# UNITED STATES PATENT AND TRADEMARK OFFICE

APPLICATION NO.	FILING DATE	FIRST NAMED INVENTOR	ATTORNEY DOCKET NO.	CONFIRMATION NO.
10/668,769	09/22/2003	Horst Friedrich	4879-23	3320

# Office Action Summary

This is a first office action on the merits of patent application S. N. 10/668,769.

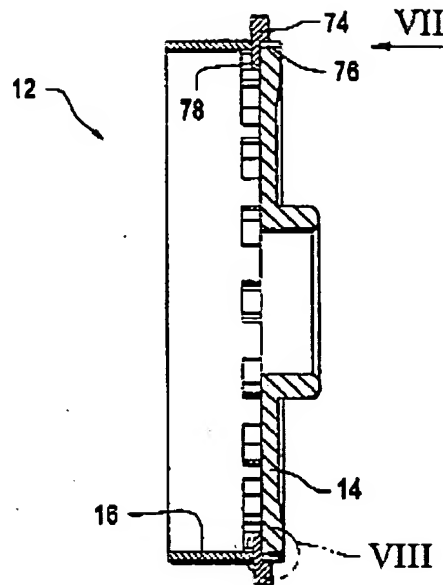
Claims 1-3, 7-12 and 15 are rejected under 35 U.S.C. 102(b) as being anticipated by Pinschmidt et al. ('276).

Pinschmidt et al. discloses a triggering arrangement (Fig. 6) for a friction clutch comprising a housing (16) made of titanium (Col. 6, line 16), at least one triggering element (74), a pickup arrangement (Col. 6, line 8), a plurality of triggering elements (88), a projection (78) and a screw (Col. 6, lines 16-20).

Claims 4-5 and 13-14 are rejected under 35 U.S.C. 103(a) as being unpatentable over Pinschmidt et al. ('276).

Pinschmidt et al. discloses the claimed invention except for the discrete triggering elements. It would have been obvious to one having ordinary skill in the art at the time the invention was made to separate the ring into multiple parts, since it has been held that constructing a formerly integral structure in various elements involves only routine skill in the art. *Nerwin v. Erlichman*, 168 USPQ 177, 179.
